Proposal for supplement 14 to the 04 series of amendments to UN Regulation No. 44 (Child Restraint Systems)

Submitted by the expert from the European Association of Automotive Suppliers*

The text reproduced below was prepared by the expert from the European Association of Automotive Suppliers (CLEPA) for UN Regulation No. 44 to amend document ECE/TRANS/WP.29GRSP/2017/38. The modifications are marked in bold for new characters.

Figures for the explanation of the measurement procedure

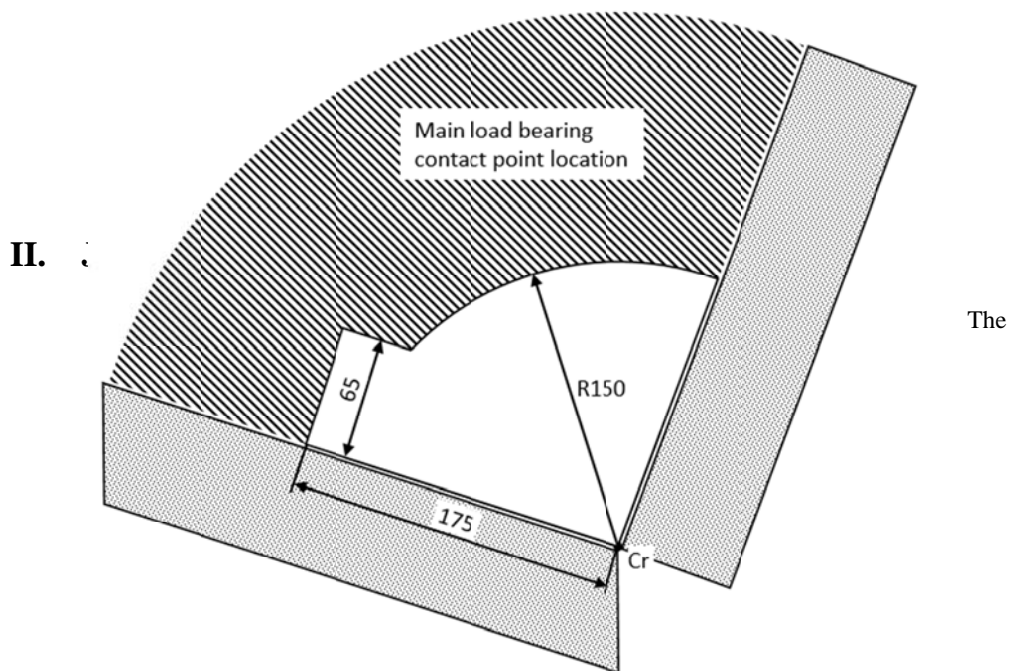
Paragraph 6.1.8., amend to read:

"6.1.8. Integral child restraint ... without a dummy.

proposal clarifies the test procedure in the amended paragraph 6.1.8 in document ECE/TRANS/WP.29/GRSP/2017/38 by adding one dimension (175 mm) . This dimension is in line with the dimensions of the fixture from Regulation 16 to check the vehicle safety belt length (Annex 17-Appendix 1, Figure 1) and also in line with document GRSP 61 14 Rev.1 that was adopted at the 61st session.
